Base Load Power Hub (BLPH)

60% 3D Model Review Report

Document Number: 123A90-DDL-PP-RE-70009

BLPH - 60% 3D MODEL REVIEW
ACTION ITEM REGISTER

MR60-TAG12

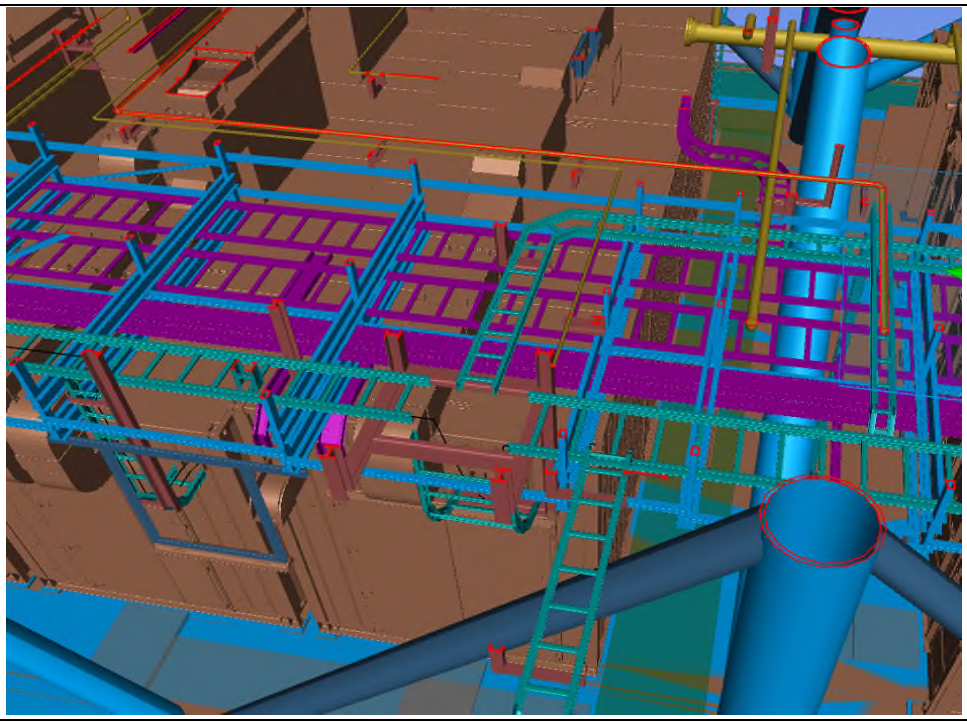
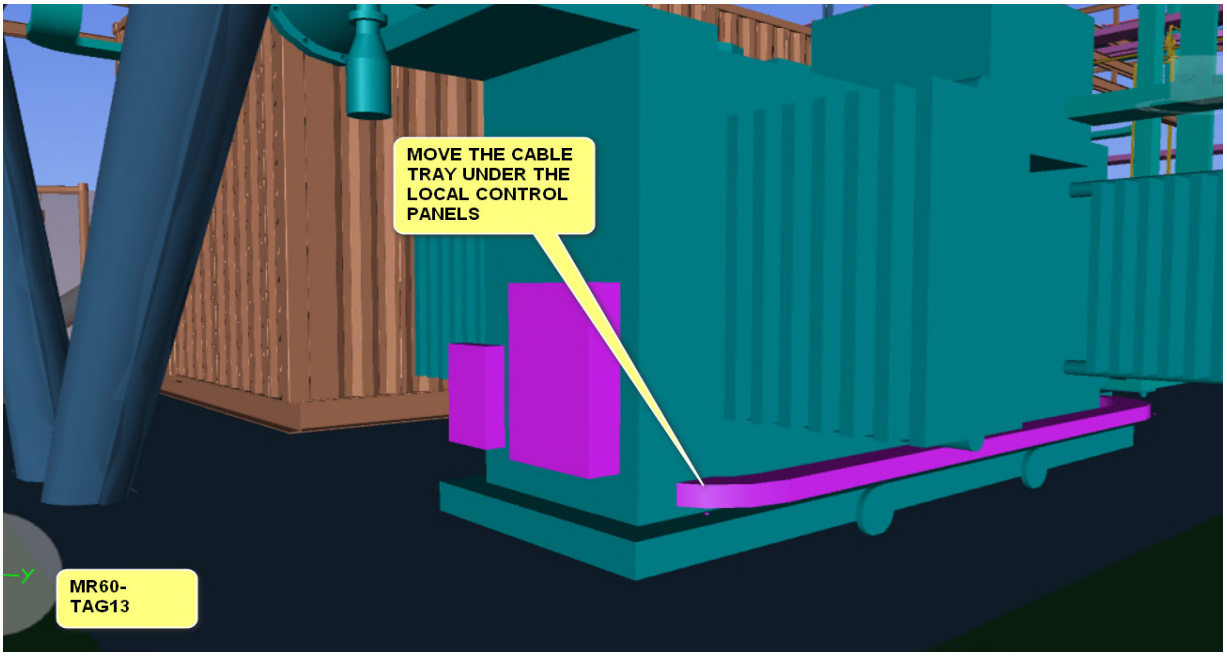
Clash to be solved

Cabletray clashes are solved

MR60-TAG13

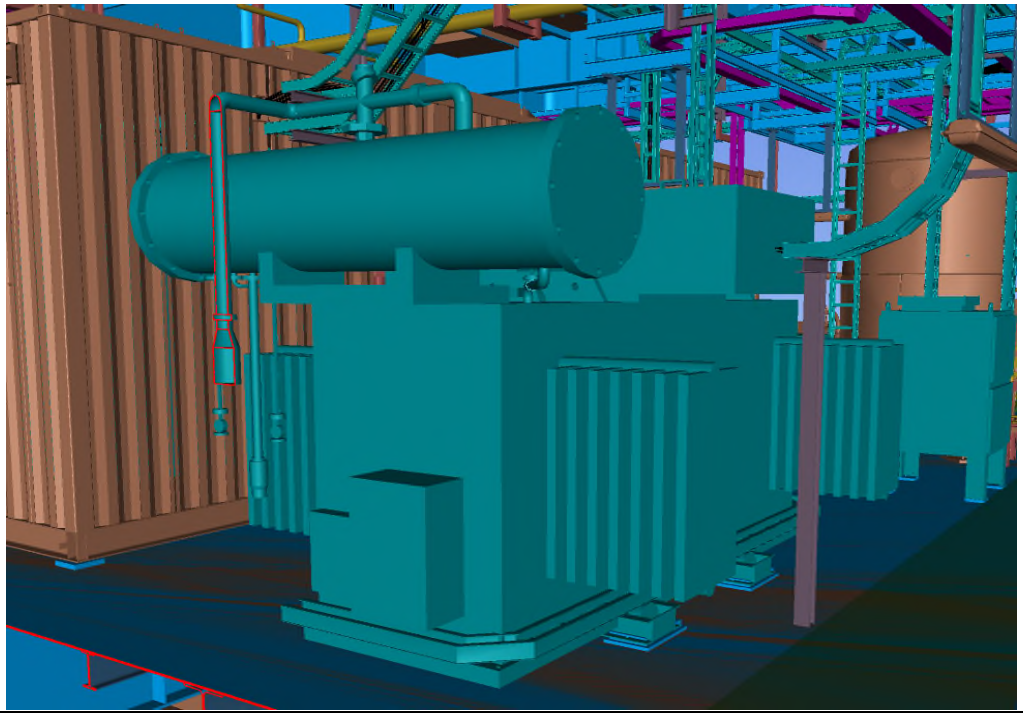
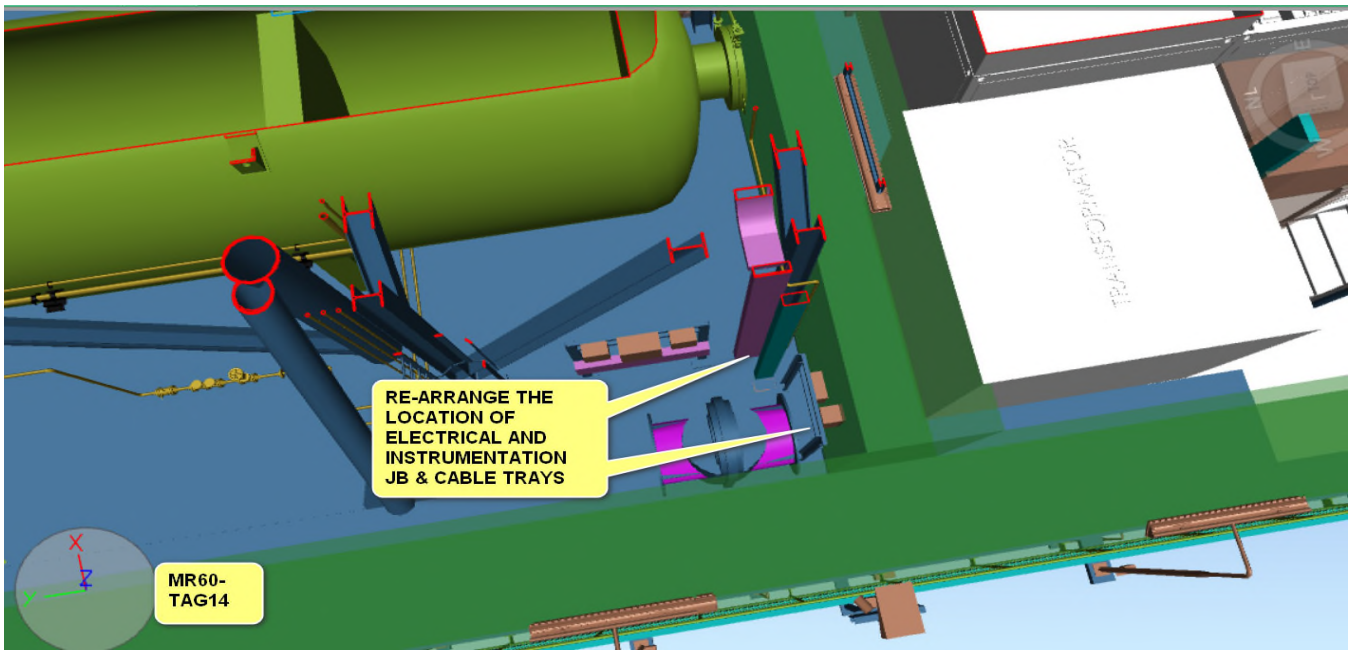
Move the cable tray under the local control panels

Cabletray has been moved under local control panels

MR60-TAG14

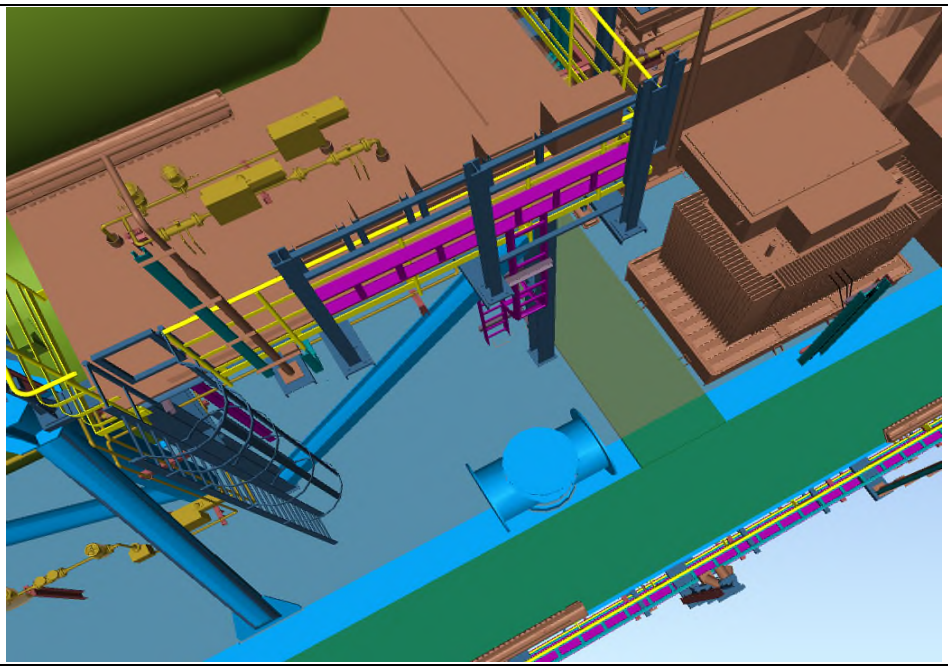
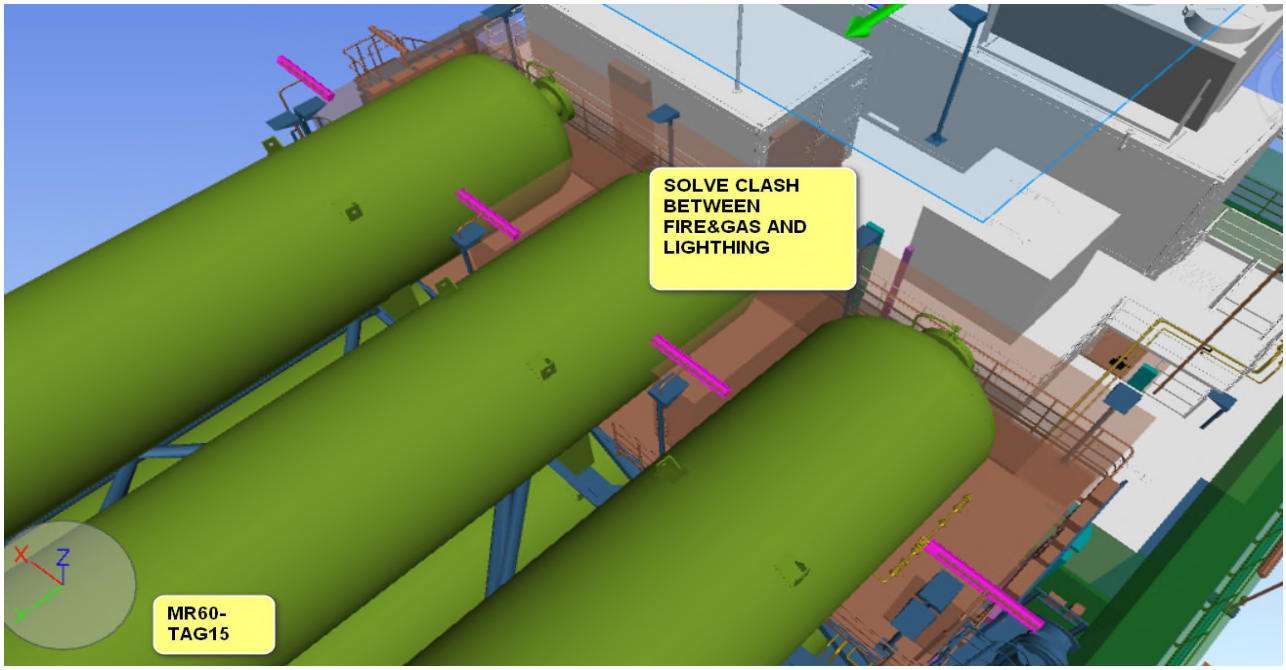
Re-arrange the location of electrical and instrumentation JB & Cable trays

Eletrical JB and Cabletray have been re-arranged

MR60-TAG15

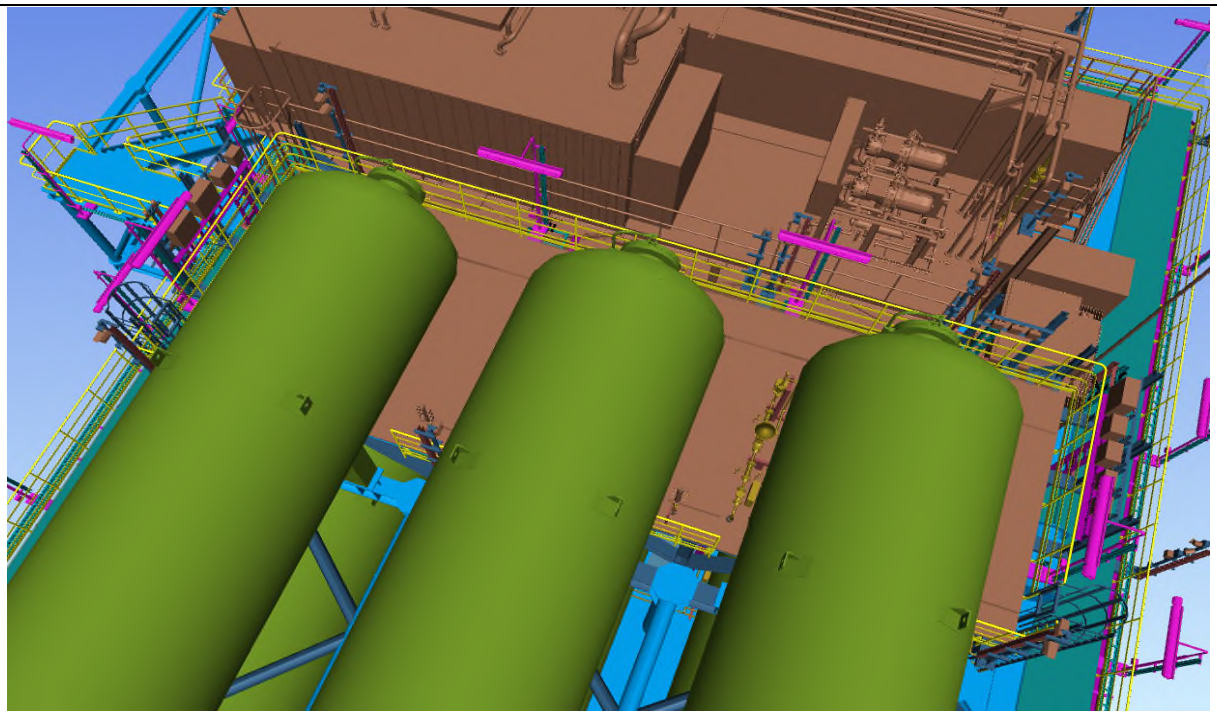
Solve clash between FIRE&GAS and lighthing

Lighting position has been modified to avoid clash with Fire&gas

MR60-TAG16

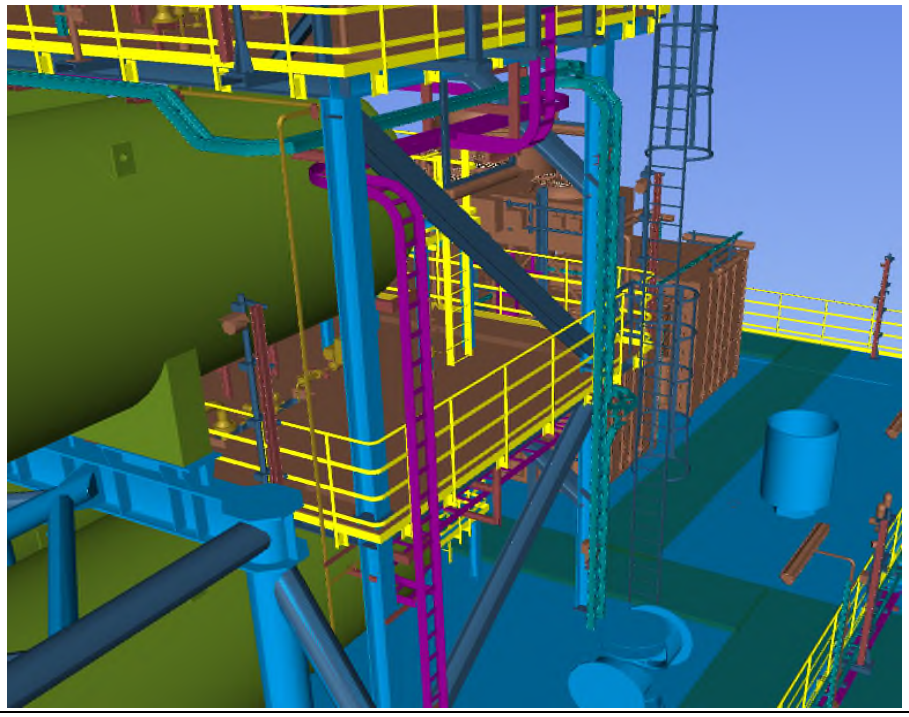
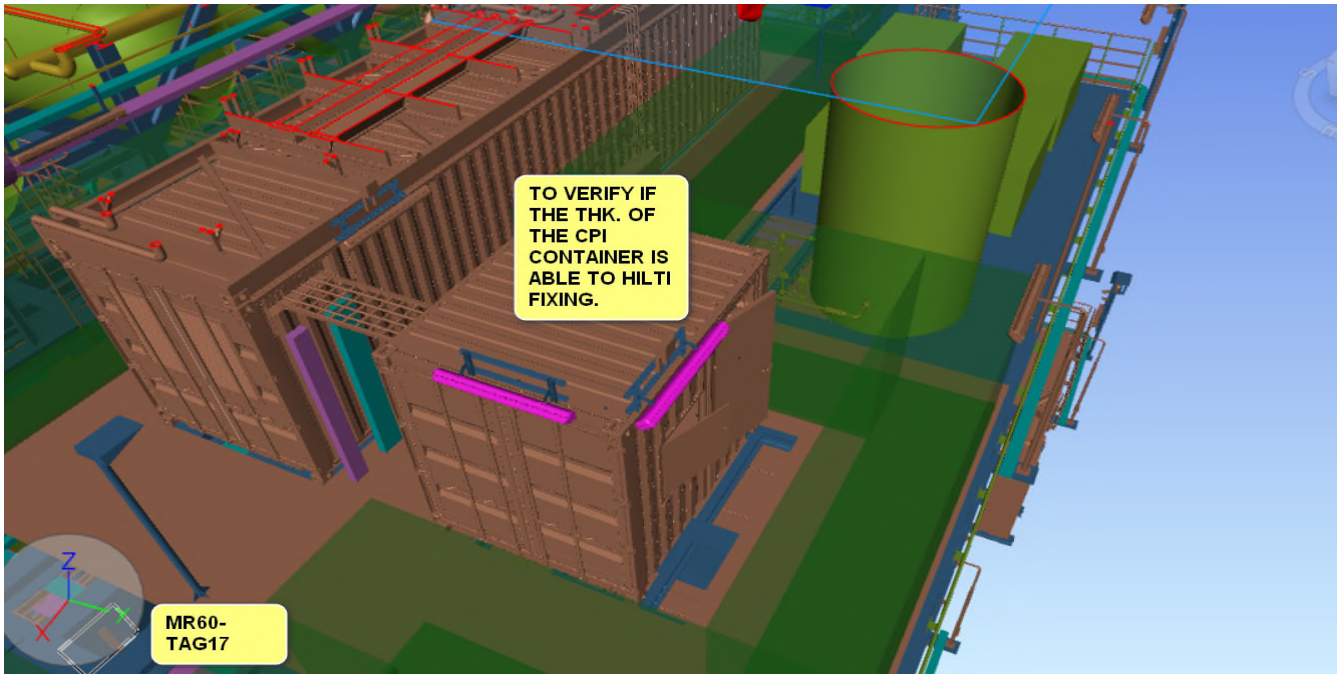
Solve clash between cable tray and handrail

Cabletray position has been modified to avoid clash with Handrail

MR60-TAG17

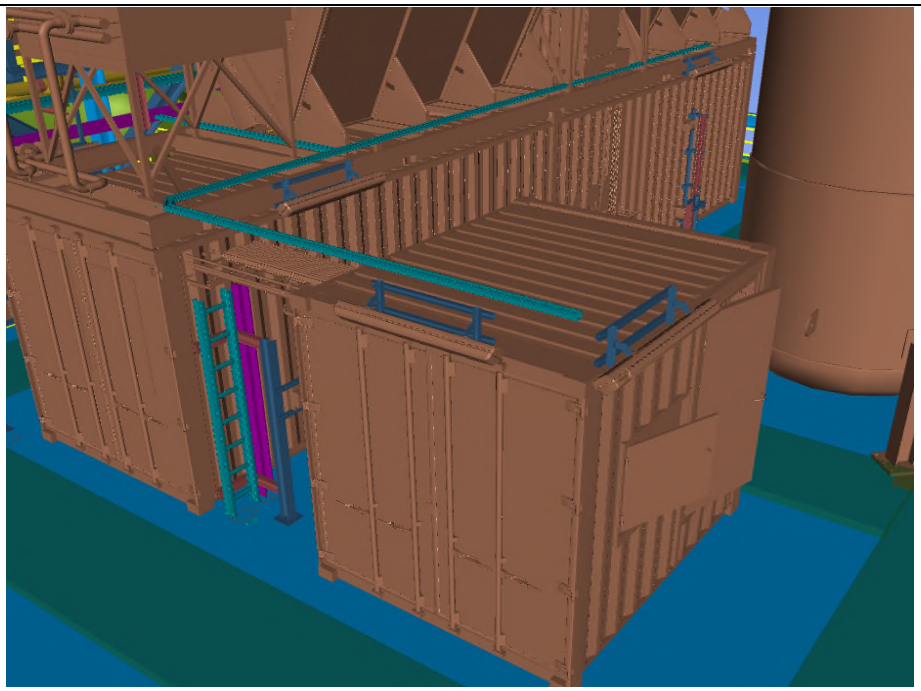
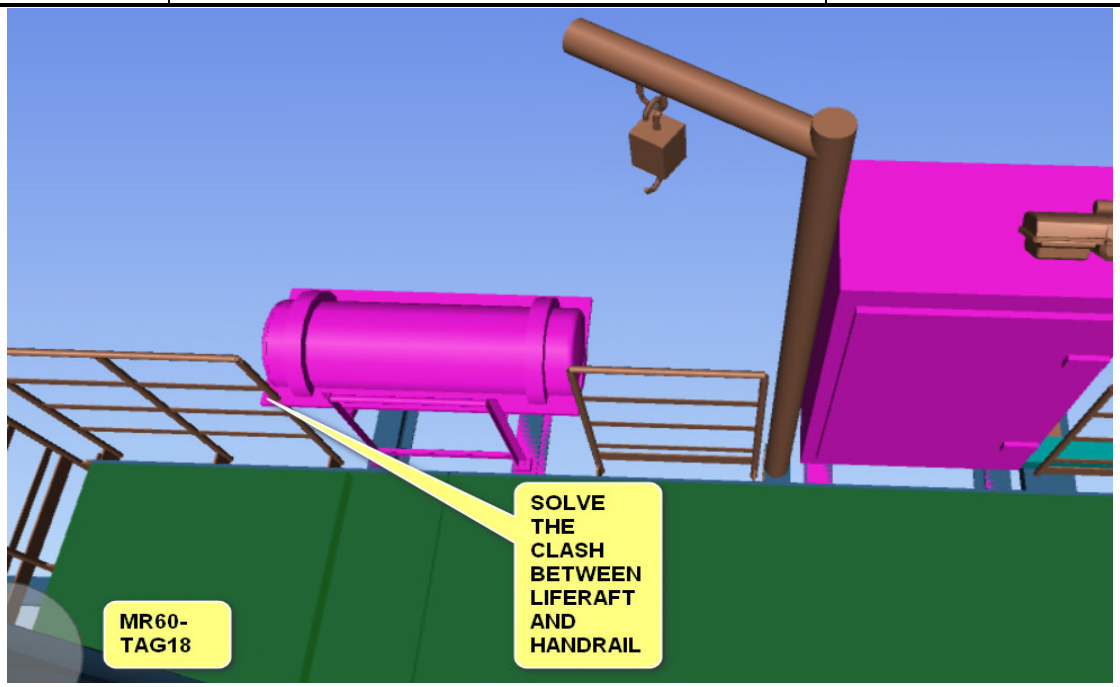
To verify if the thickness of the CPI container is able to Hilti Fixing

Thickness of the Ballard's container is able to the fixing.

MR60-TAG18

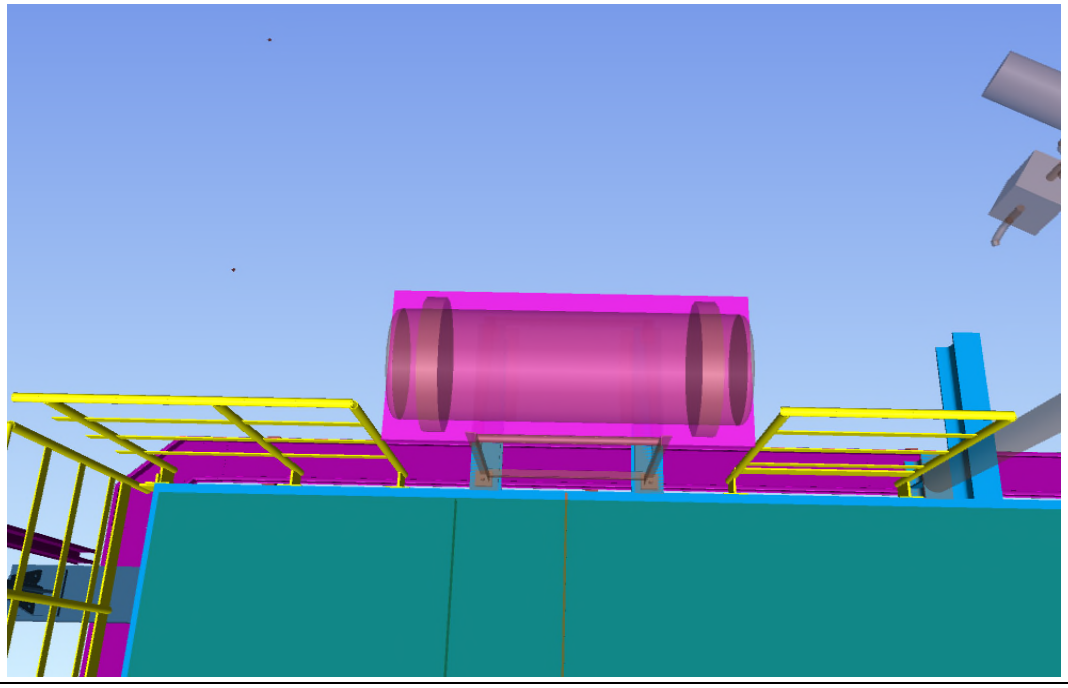
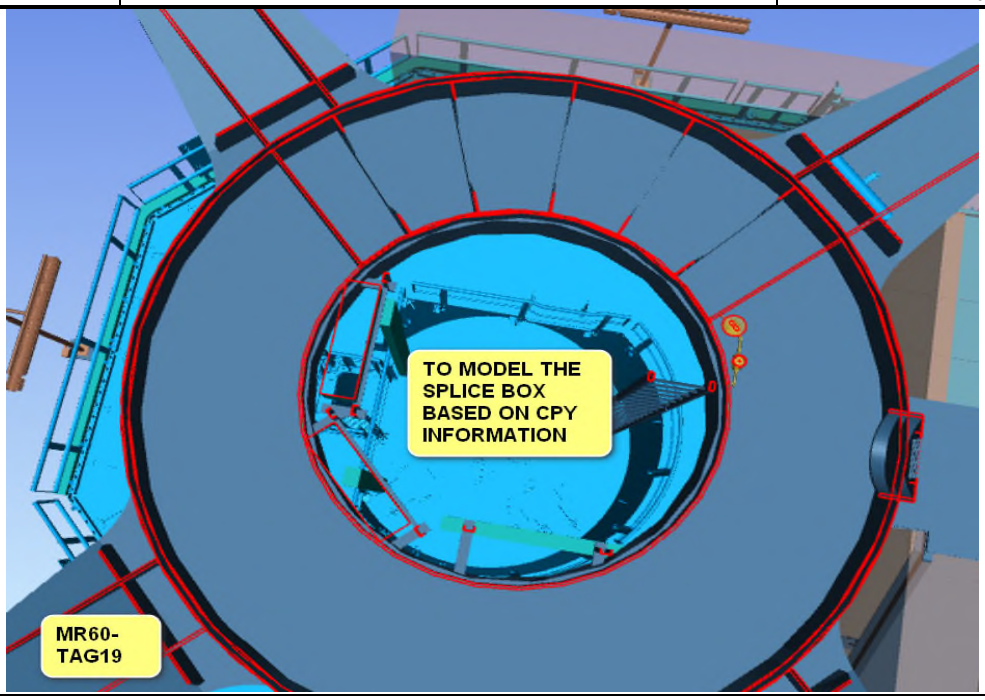
Solve the clash between liferaft and handrail

Clash solved

MR60-TAG19

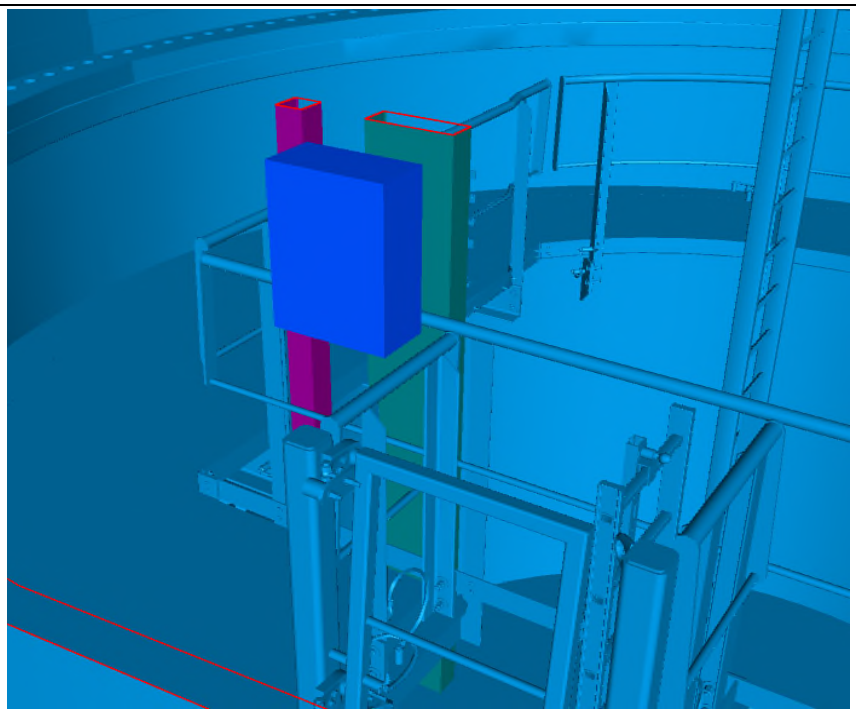
To model the splice box based on CPY information

Splice Box modeled.

MR60-TAG22

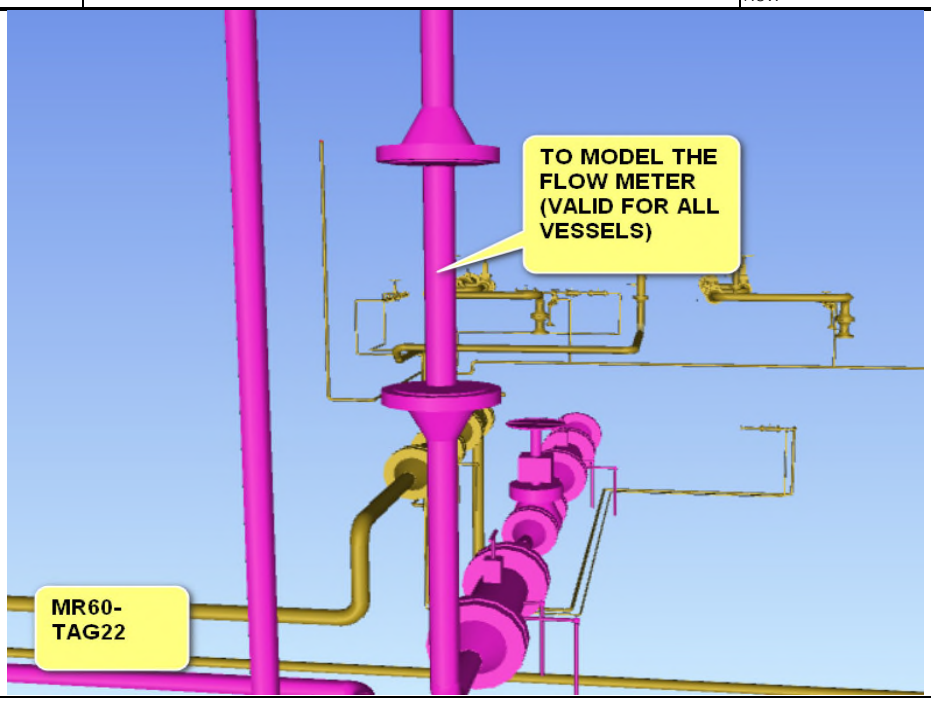
To model the flow meter (valid for all vessels)

The Flow meter has been modeled based according to the vendor drawing received.
